(6) VACUUM PUMP MADE OF METAL

Study Group for Medical Technology
and Medical Supplies
(SanTechnik SanMaterial)
Department for Studies and Science
Academy for Medical Service and Sanita-
tion of the Bundeswehr (SanAkBw)
Ref.: 90-65-15

Subject: Vacuum Pump Made of Metal

Treadle vacuum pump,
metal

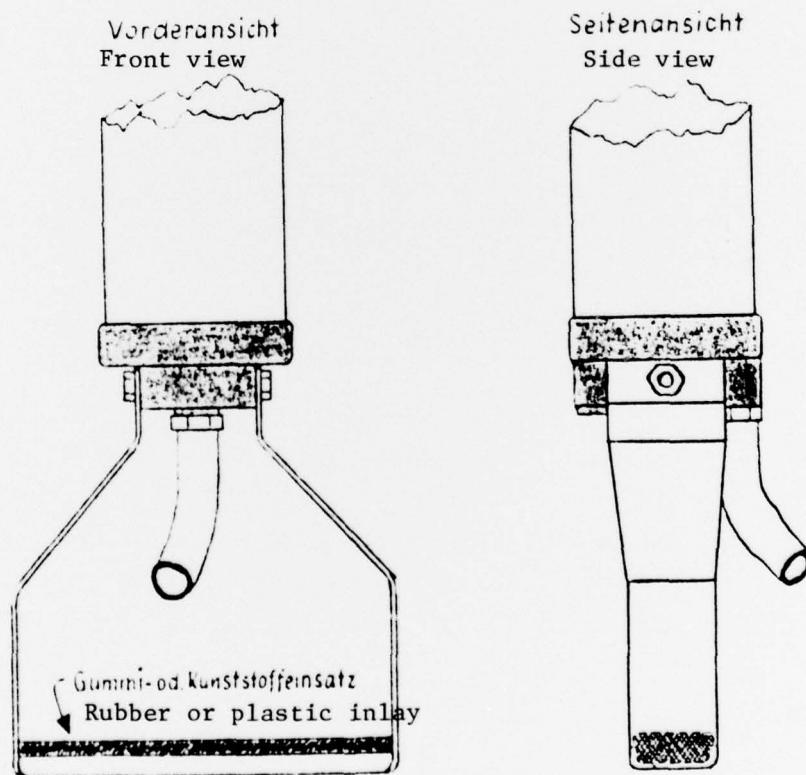
However, in order for the pump to be still better utilized for manual and treadle operation and to enable a simple harmless attachment to the vacuum stretcher, the following changes are proposed: (cf. technical drawing as inclosure on this subject*)

1. The foot section should be kept narrower in the width of the area for the foot and be provided with a nonskid rubber or plastic inlay.
2. The web edges should be flanged for increasing web stability.
3. The width of the treadle should remain on the body of the pump as in the model in order for the treadle to keep enough buckling strength.

A pressure hose used as general supply article in the Bundeswehr should be utilized as pump hose.
